NOVEMBER 2019

PL6

NON MATERIAL
AMENDMENT
PLANNING
APPLICATION
& CONDITION 4
DISCHARGE

44 A GLOUCESTER
AVENUE LONDON
NW1 8JD

2.3 CHANGES TO CONSENTED DEMOLITION REAR AND SIDE ELEVATIONS

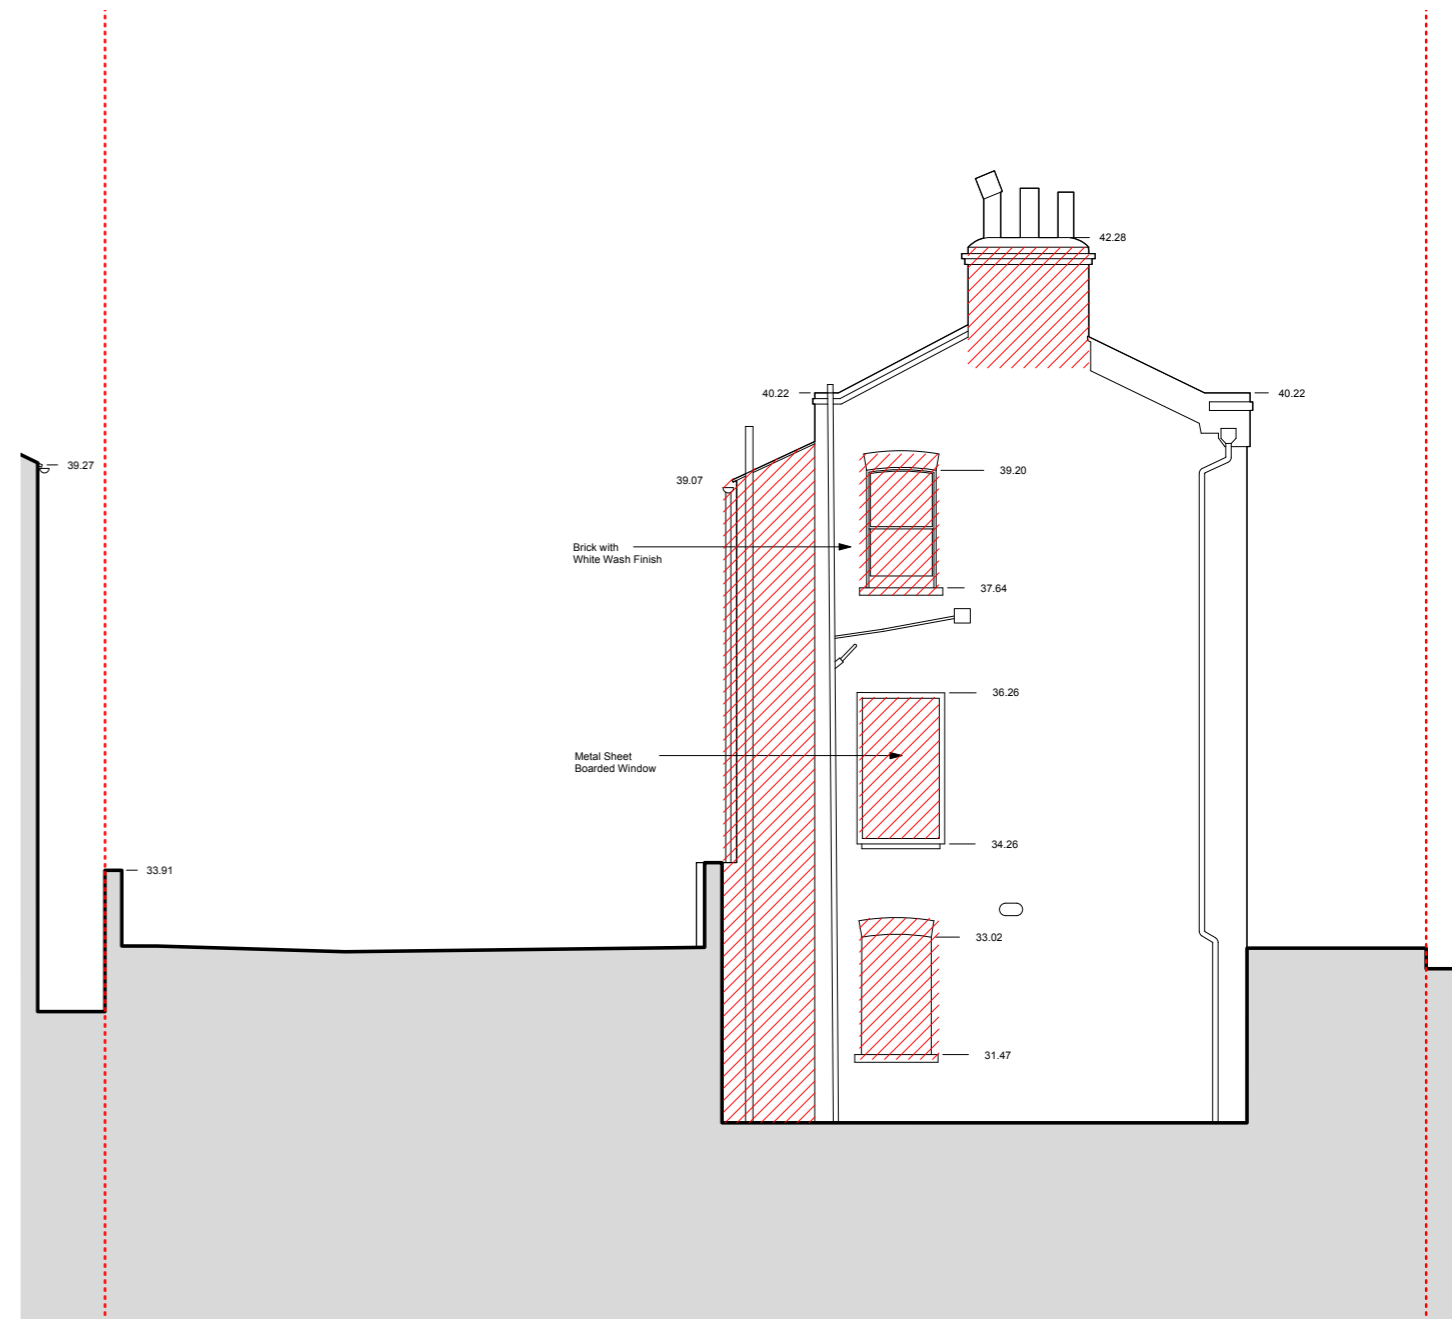
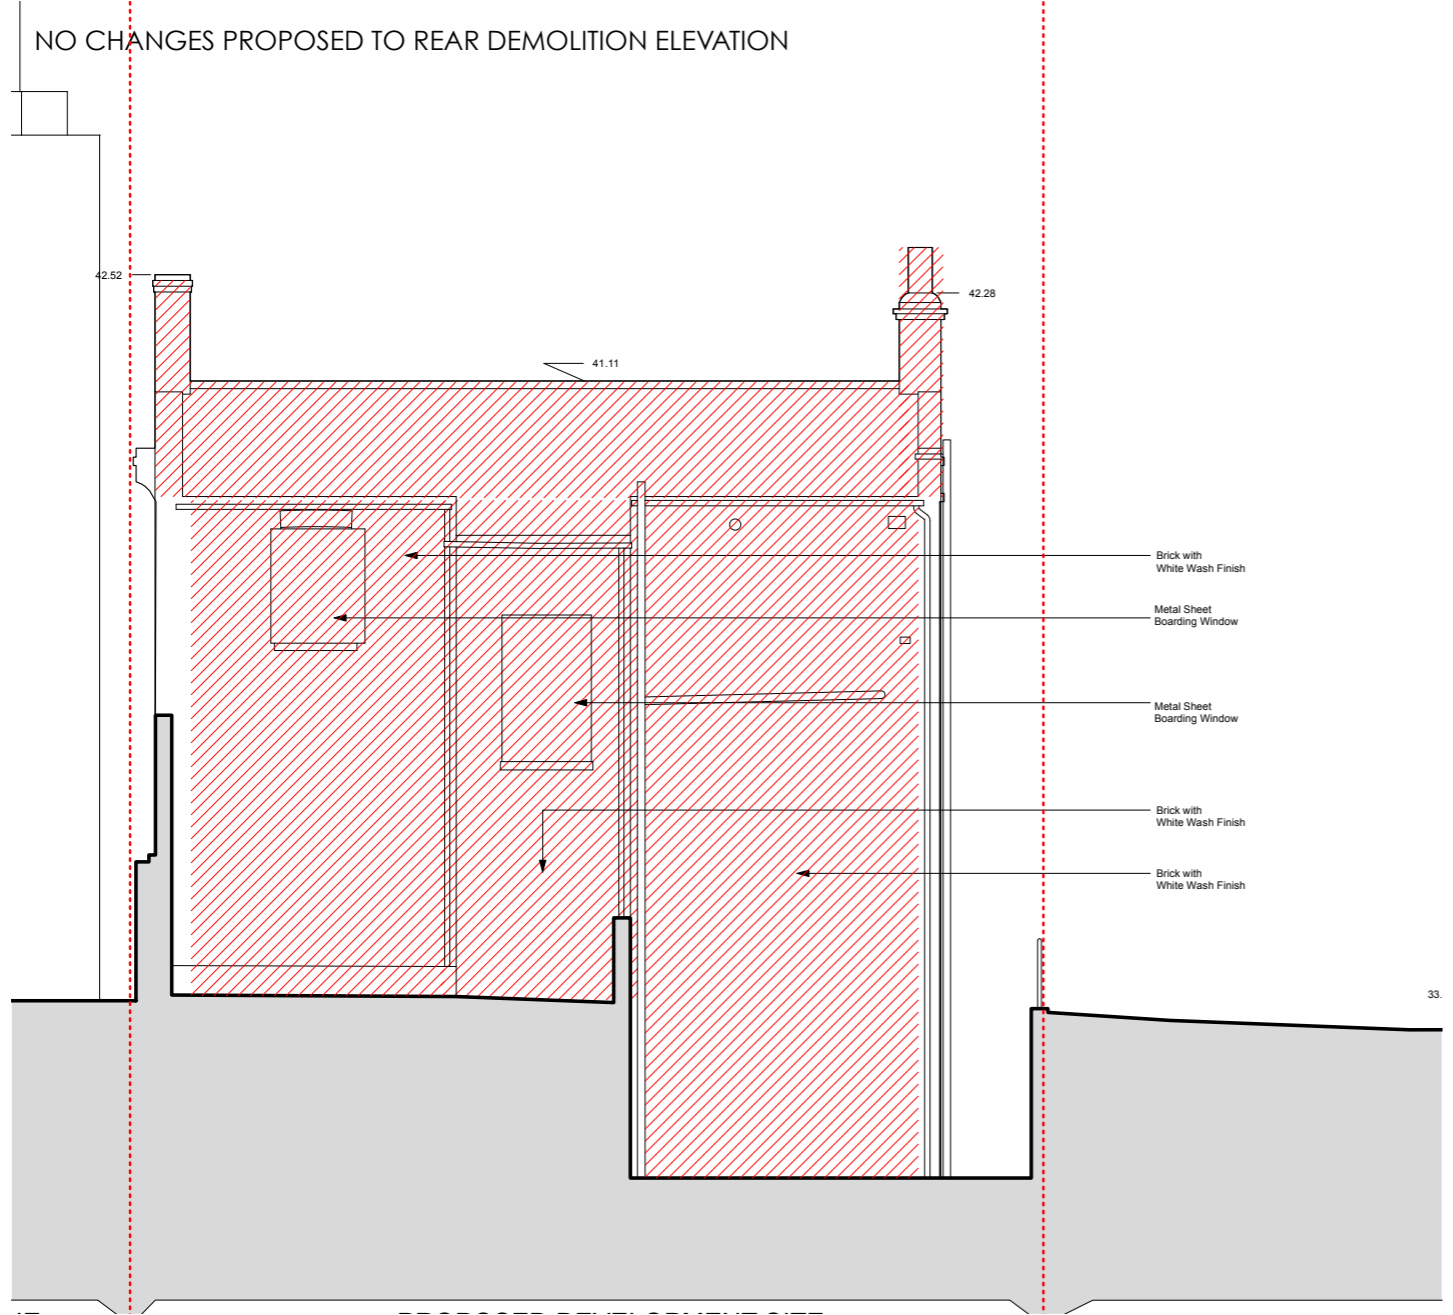
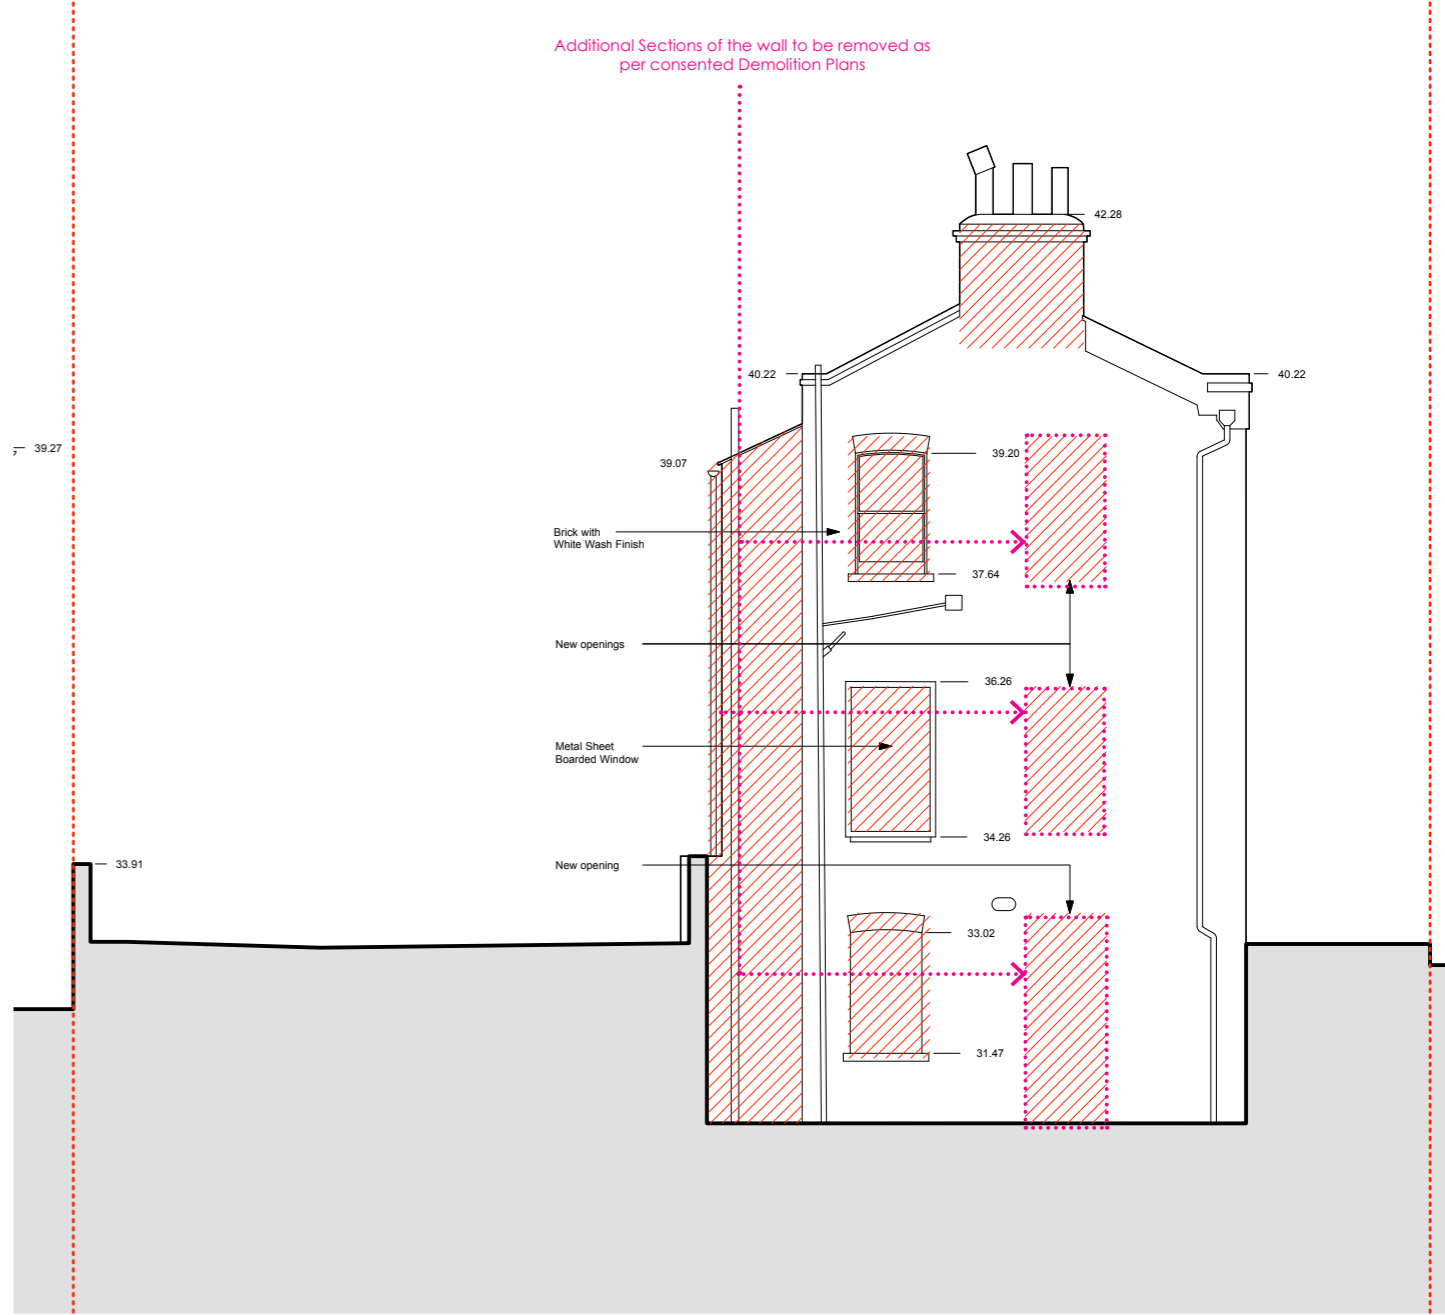
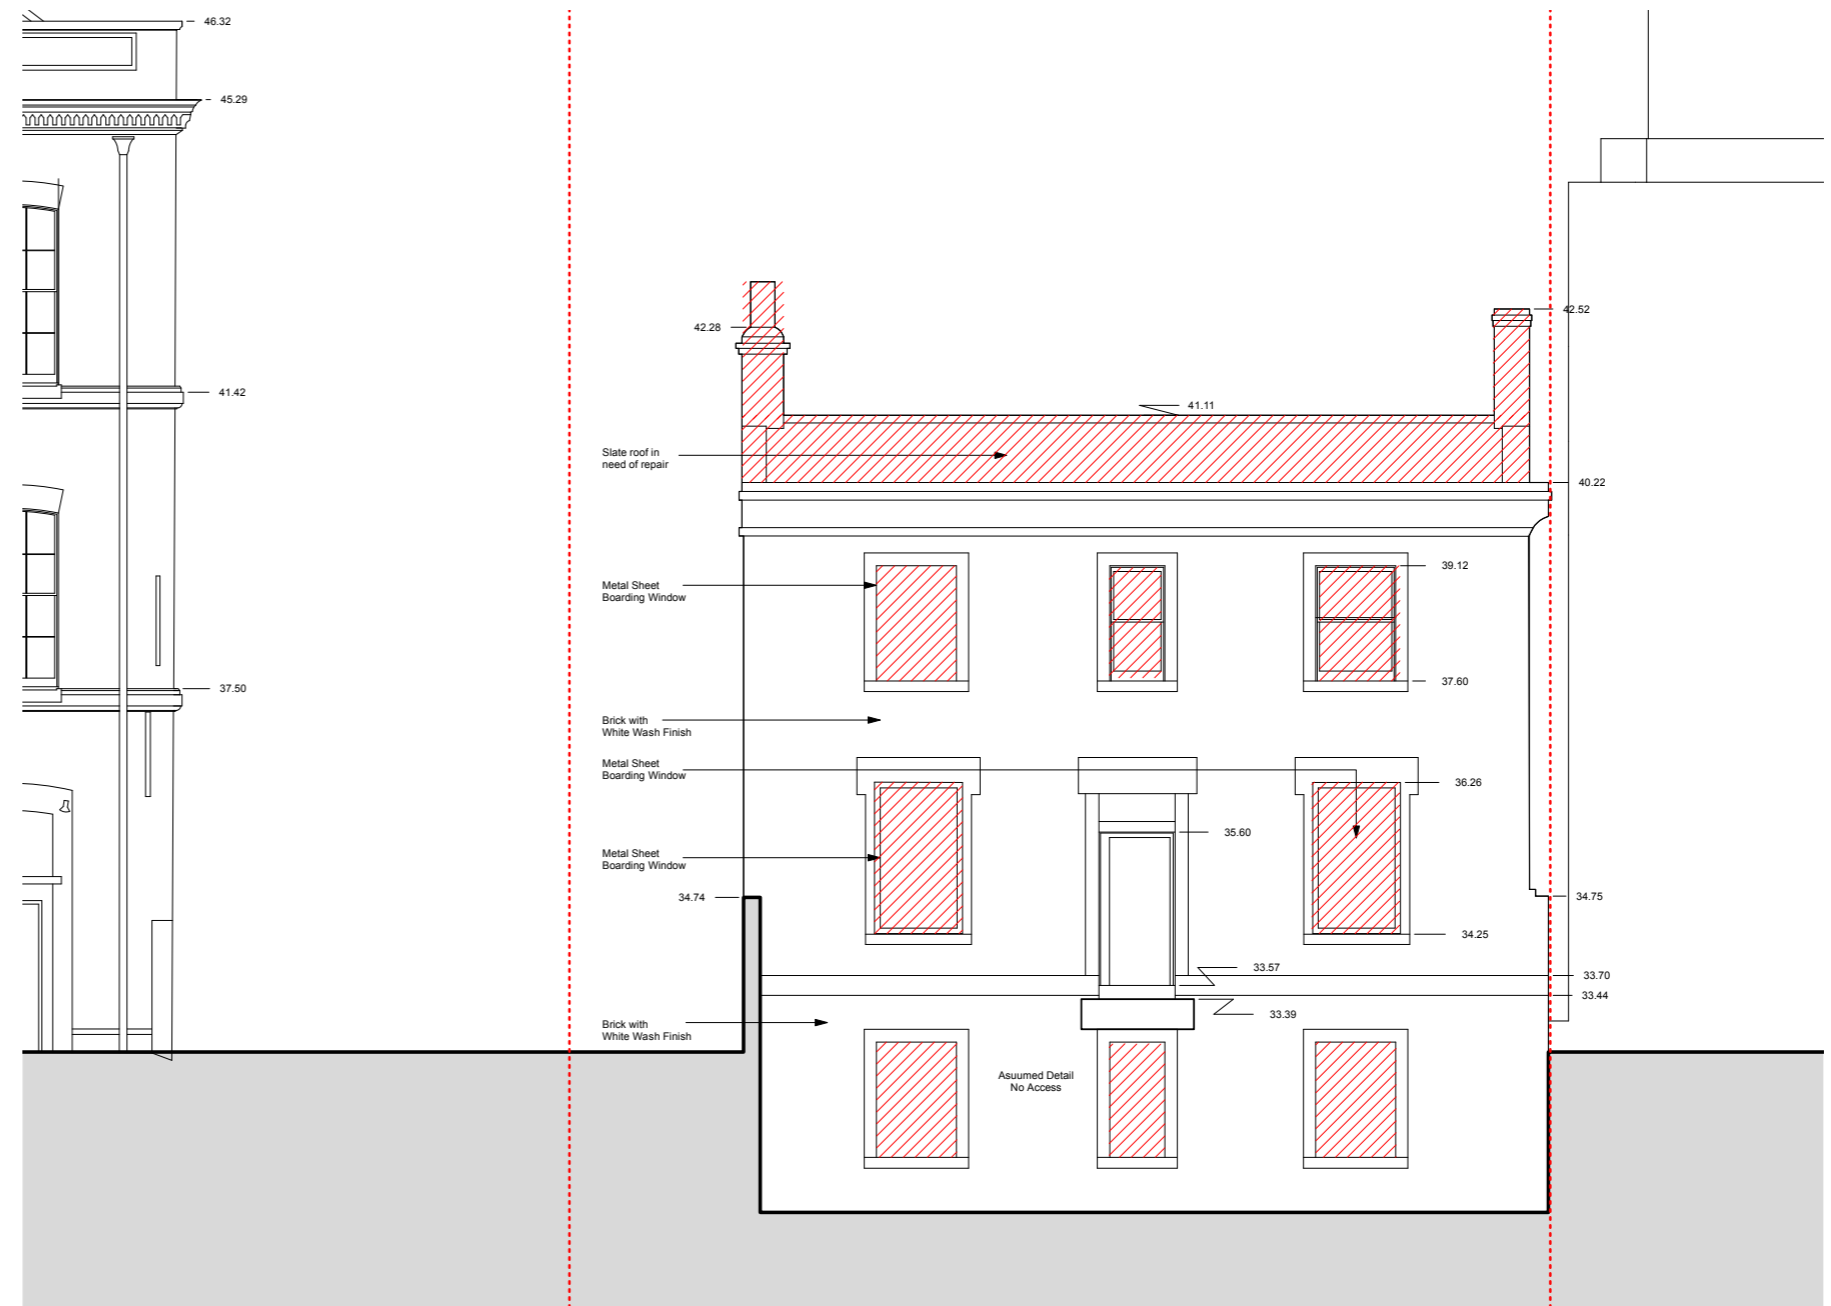
- Due to incorrect initial survey basement front balcony opening has been revised in the demolition drawings
 - Demolition drawings have been revised with correct openings in the side elevation and other minor changes
